Freedom 458 Auxiliary Switch Port Errata

Freedom 458

976-0137-01-01 Rev A

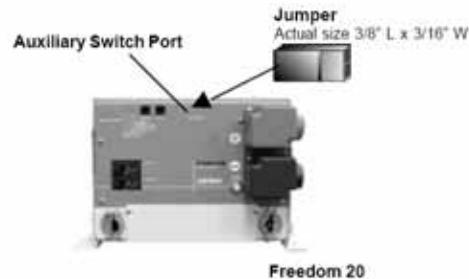
In early versions of the Freedom 458 — which includes all inverters with software revision 4.0 and earlier or units which were produced before 2001 — the installation of a jumper is necessary for operation of the inverter/charger when a remote isn't used. This is explained in the manual and detailed in the Figure below. All 458 inverters manufactured prior to 2001 included a jumper in the accessories bag to facilitate the installation of the inverter.

13. An Auxiliary Switch port is located on the front panel of the unit, covered by a flap. When installing the unit for operation without a Remote Control Panel or Link Instrument, a jumper must be installed in the Aux Switch port. The jumper is shipped in a plastic bag with other installation parts. DO NOT install the jumper until all cable connections have been made.
When using a Freedom Remote Control Panel or Link Instrument, the jumper is not used.

Current versions of the product do not require the installation of the jumper, because it is no longer necessary for operation of the inverter when used without a remote control. The Auxiliary Switch Port can now be used to turn the inverter on with the use of a contact closure. Connecting these two pins together turns the inverter on, and disconnecting them turns the inverter off. Some RV manufacturers use this feature to power a back-up camera and a 120 Volt TV.
